<p>Date: October 18, 2021</p> <p>Item #: P21-268</p> <p>Planner: Tyler Valentine</p> <p>Phone: 733-0440 ext. 1305</p> <p>Email: tvalentine@jacksonwy.gov</p> <p>Owner CCC's Ranch Inn, LLC PO Box 844 Jackson, WY 83001</p> <p>Applicant: Northworks Architects PO Box 4027 Jackson, WY 8.001</p>	<p>REQUESTS:</p> <p>The applicant is submitting a request for a Sketch Plan for the properties located 50 S. Cache (PIDN: 22-41-16-34-2-05-006), 45 E. Pearl Avenue (PIDN: 22-41-16-34-2-05-007), and 75 E. Pearl Avenue (PIDN: 22-41-16-34-2-05-008), legally known as N 1/2 LOT 14-16, BLK. 1, CACHE-1 , LOT 12-13, S 1/2 LOTS 14-16 BLK. 1, CACHE-1 and LOT 10-11, BLK. 1, CACHE-1 respectively.</p> <p>For questions, please call Tyler Valentine at 733-0440, x1305 or email to the address shown below. Thank you.</p>
<p>Please respond by: November 2, 2021 (Sufficiency) November 9, 2021 (with Comments)</p>

CONDOS AT CACHE + PEARL

SKETCH PLAN SUBMITTAL

RESPONSES TO THE
TOWN OF JACKSON
PLANNING DEPARTMENT
PRE-APPLICATION
CONFERENCE
(30 JUNE 2021)

PEARL AVENUE ELEVATION

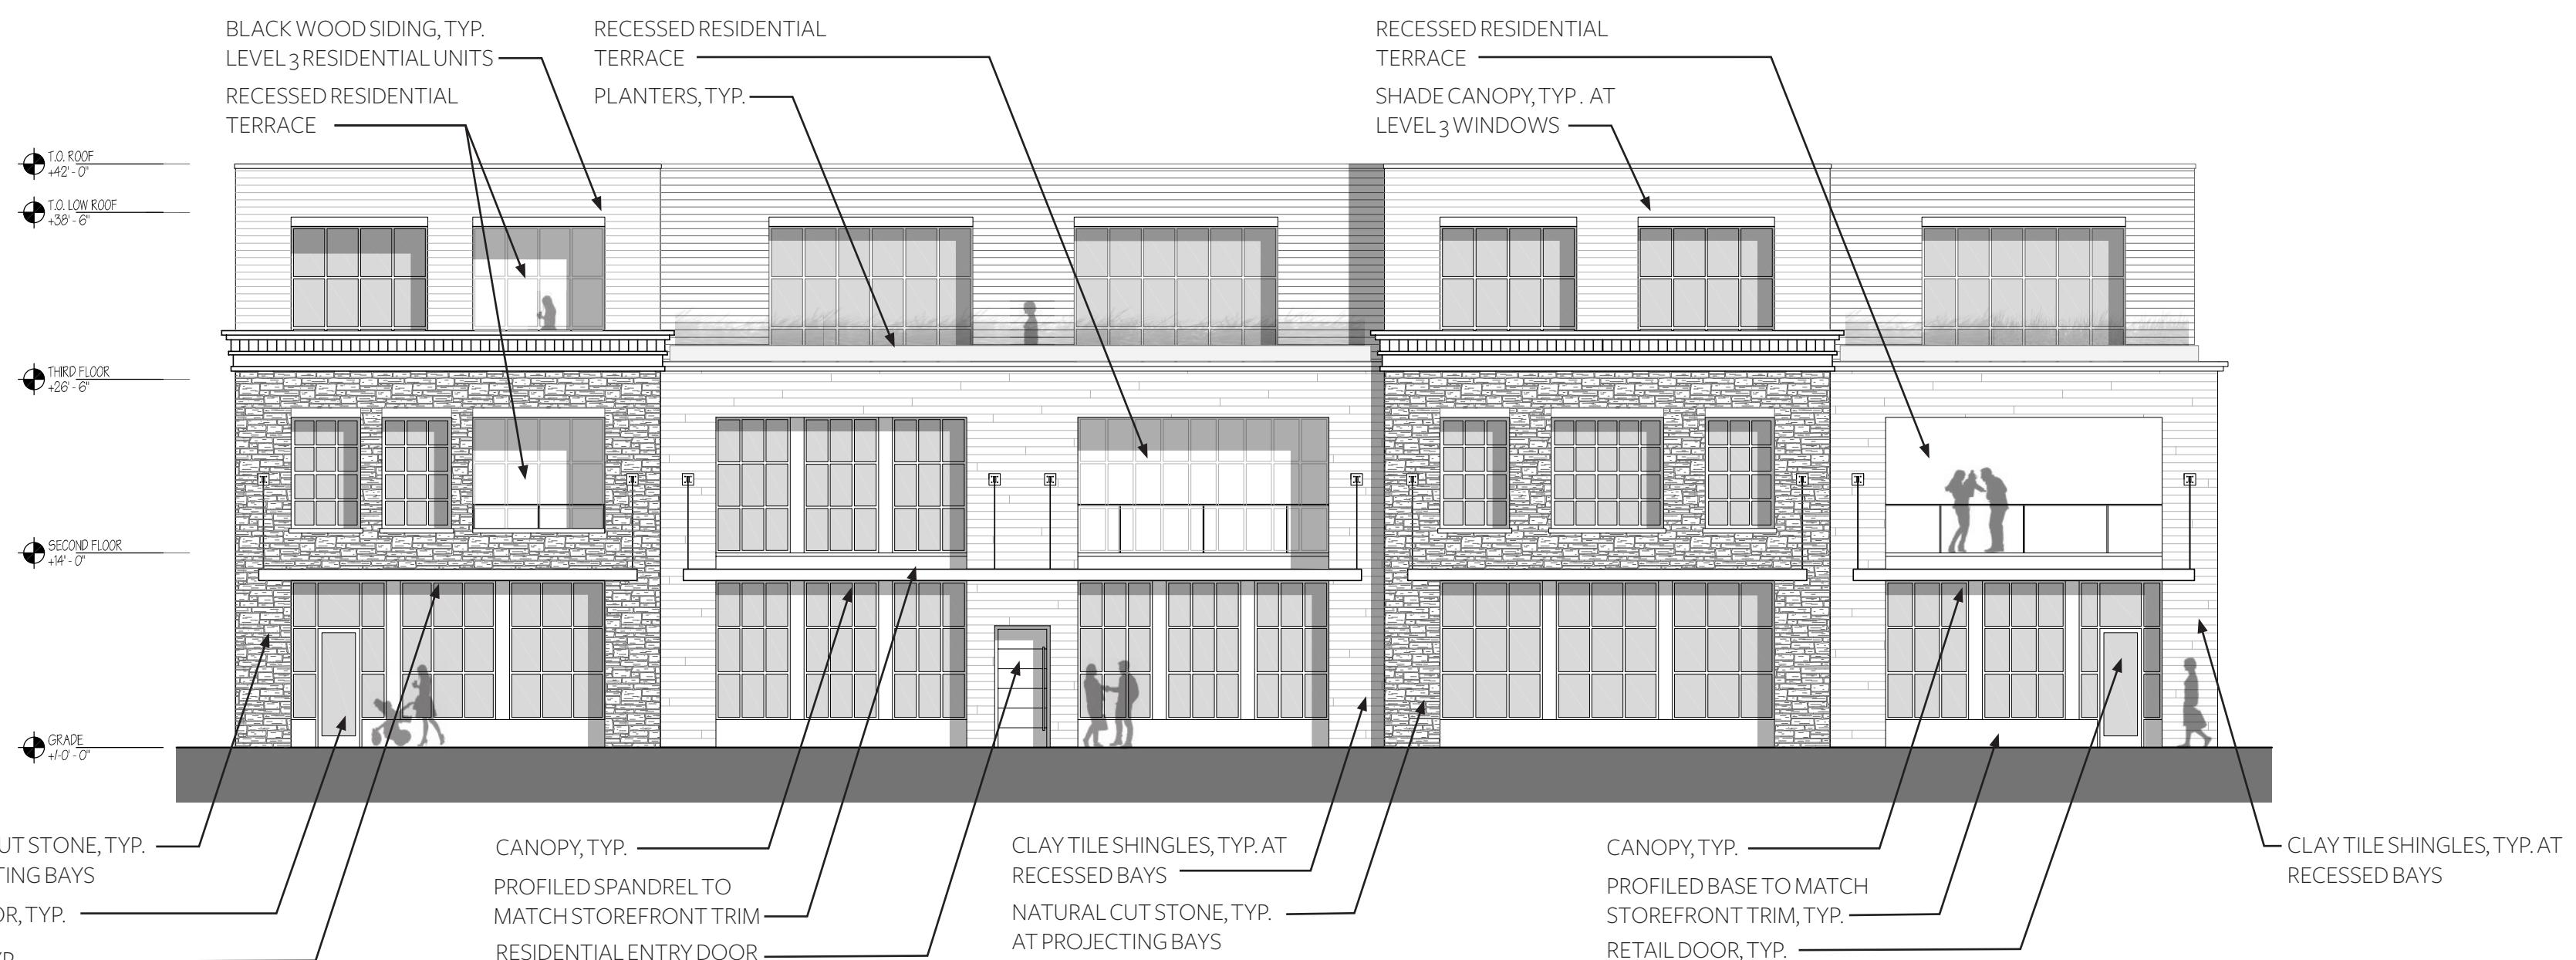
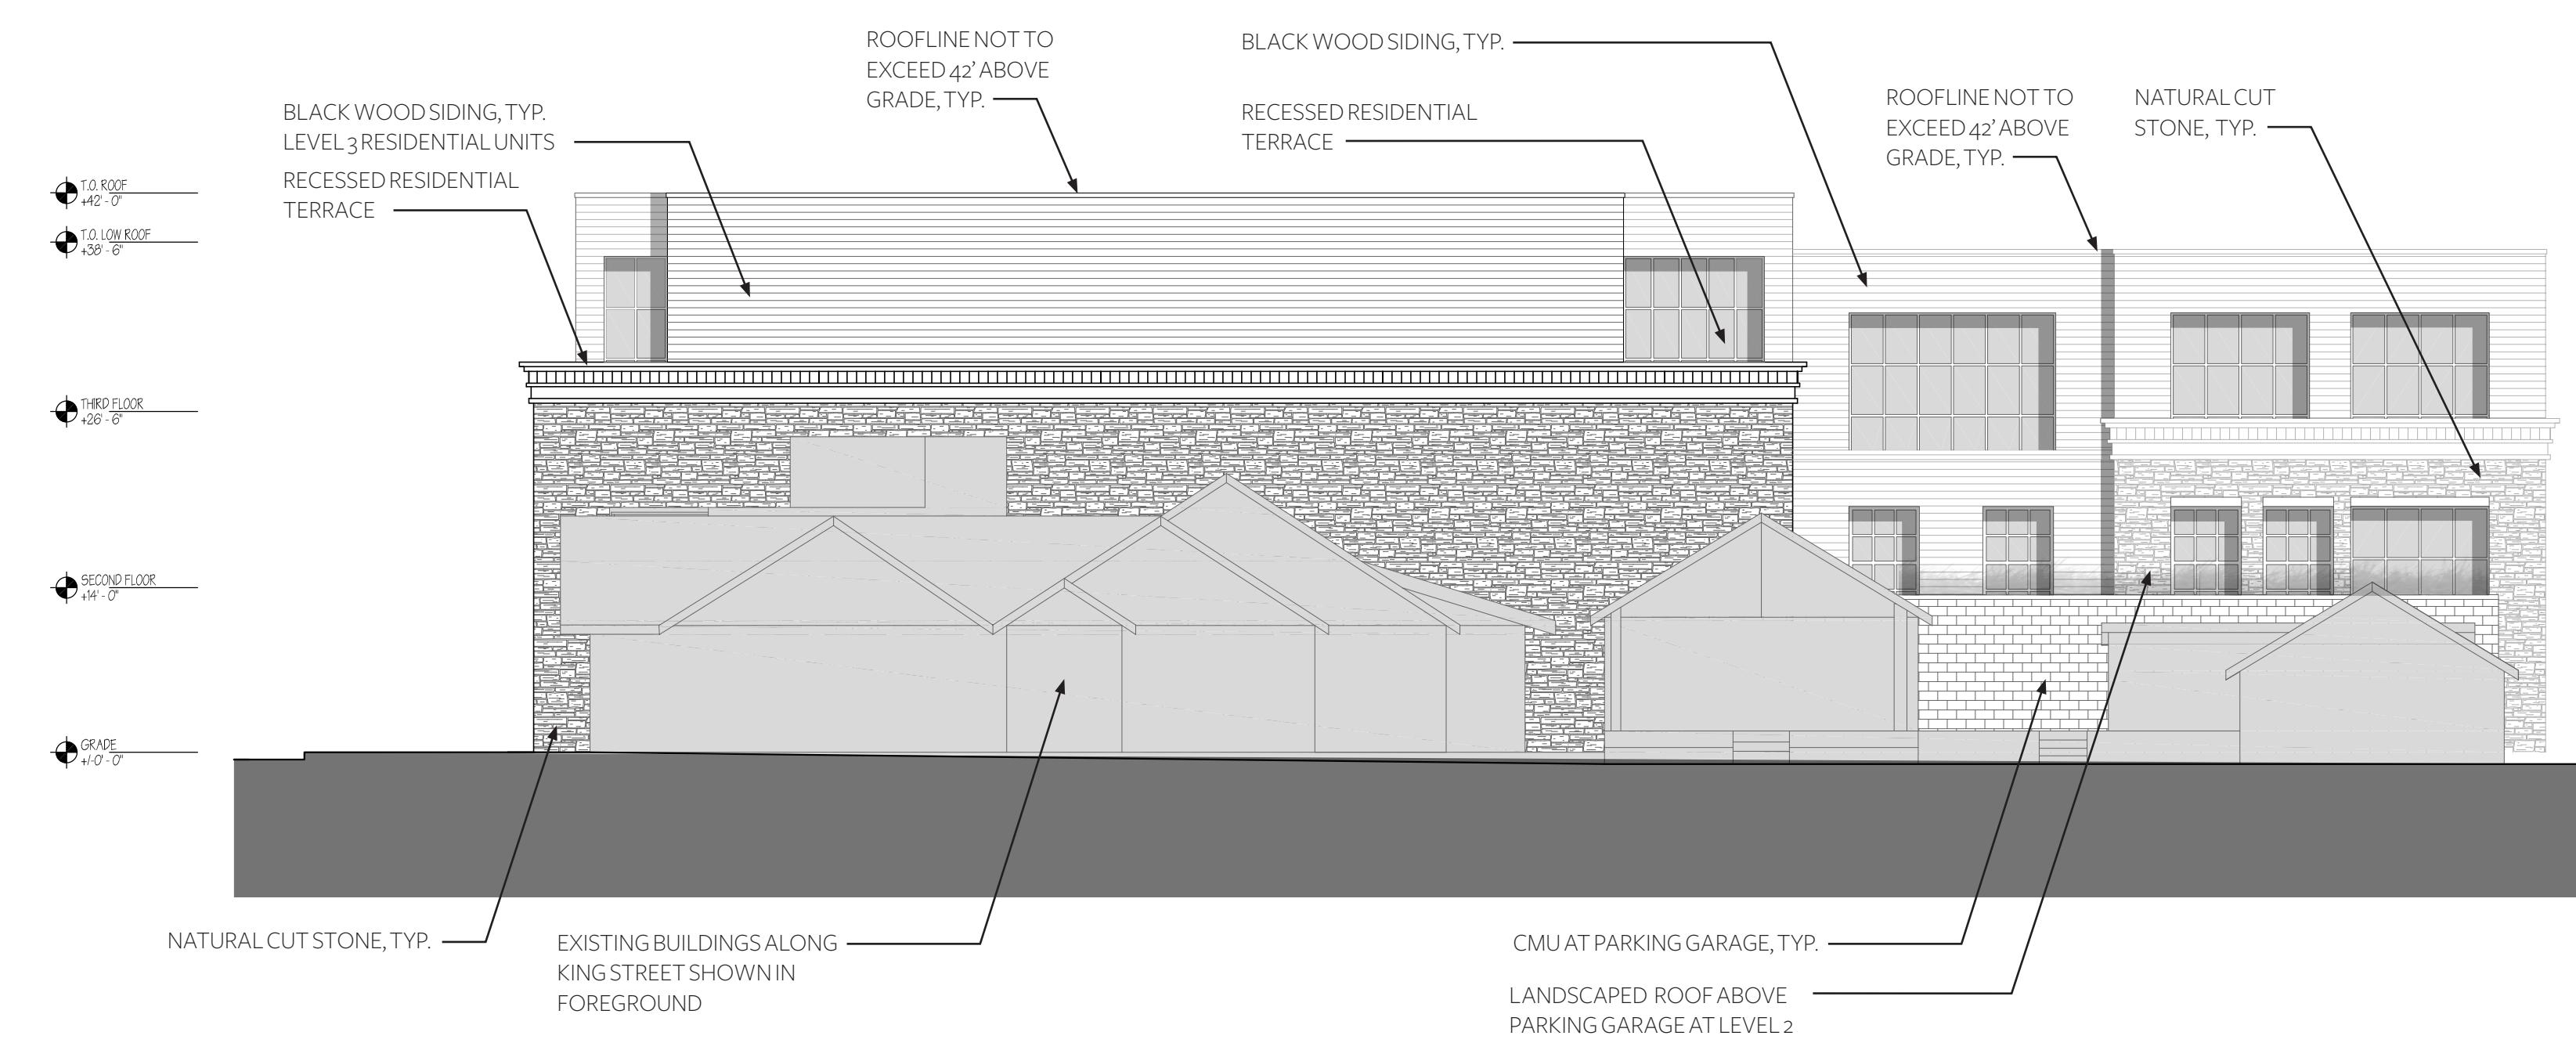
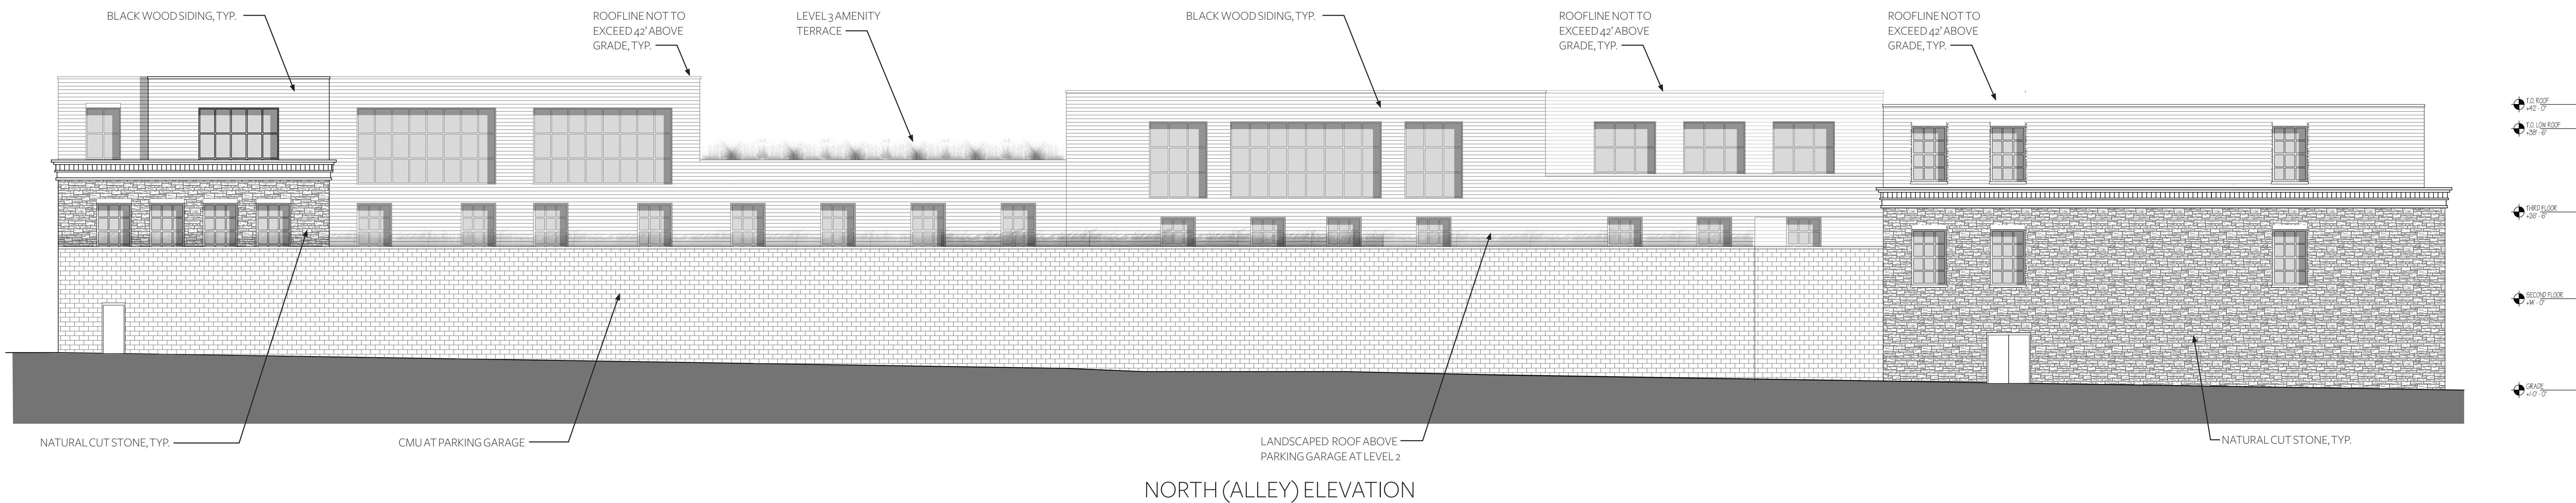
1. Massing: The general subtractive/additive massing looks very good. On the Cache frontage, staff recommends stepping the building down from 3 stories to 2 stories so that it transitions well with the property to the north (10 E Broadway) which is in the TS-1 zone allowing a max of 2 stories. If project extends all the way to Sweetwater block, staff strongly recommends that the building step down to 2 stories if possible here too.

2. Single project massing: In addition to the subtractive/additive massing, the project will need to address its massing using horizontal and/or vertical techniques (see Sec. 1.16/1.22) to meet the Design Guidelines (both regular and DDO – see below). This is because the project is being proposed as a very large, unified project (approx. 350' of frontage on Pearl if carried to the Sweetwater property), which means that perhaps the key issue for this project will be finding creative ways to break up the massing into much smaller modules (see Sec. 1.13.a, b & c). For example, a monolithic building designed like the Marriott on Simpson Avenue will not be acceptable in this location in the DDO.

4. First story windows/transparency: The amount of glazing should be similar to traditional Jackson buildings (see Sec. 1.21). Concept drawings show street level floor to ceiling windows which is too much, might try a kick plate or some other techniques to reduce glazing. The second story windows also show more transparency than traditional structures.

5. Materials: The variable brick is very good per Sec. 1.23/1/24/1.27, however, using only one type of brick for a building this size may not meet all the DDO guidelines, especially the goals of breaking the building into modules. Perhaps consider the use of different colors/textures of bricks in clean logical manner.

Since the comment was made, the applicant has refined the building design, setbacks, and overall massing. The design contained within this sketch plan submittal was unanimously approved by the Design Review Committee ("DRC") on October 13, 2021. The proposed building design includes a setback at the third level across 100% of the Cache Street and Pearl Avenue frontages. The setbacks range from 3 feet to 20 feet which exceed the land development regulations requirements.

Since the comment was made, the applicant has refined the building design and overall massing. The design contained within this sketch plan submittal was unanimously approved by the Design Review Committee ("DRC") on October 13, 2021. Smaller modules and variability in the materiality of the exterior are included as part of the design strategy to address the design guidelines. The proposed building design includes projected and recessed modules of different materials which breaks the scale of the building into smaller sections. These modules have also been organized to provide a hierarchy and order between the retail and residential entrances.

Since the comment was made, the applicant has significantly reduced glazing at both street level and upper stories using a variety of techniques that more closely align with traditional structures. The proposed building design was unanimously approved by the DRC on October 13, 2021, and features kick plates below the street level storefront glazing, and a variety of punched window types on the second floor.

Since the comment was made, the applicant has refined the building design to incorporate additional materials to the exterior facades that align with the DDO guidelines. The submittal was unanimously approved by the DRC on October 13, 2021. The proposed building design has eliminated brick as a building material and now features a material palette of stone and clay tile shingles at Levels 1-2, black cedar siding at Level 3, stained cedar plank exterior ceilings and canopies, black aluminum windows, and black metal and wood detailing at the canopy structures and cornices, respectively. These material changes are a direct response to the comments received and further support the project's compliance with the Design Guidelines.
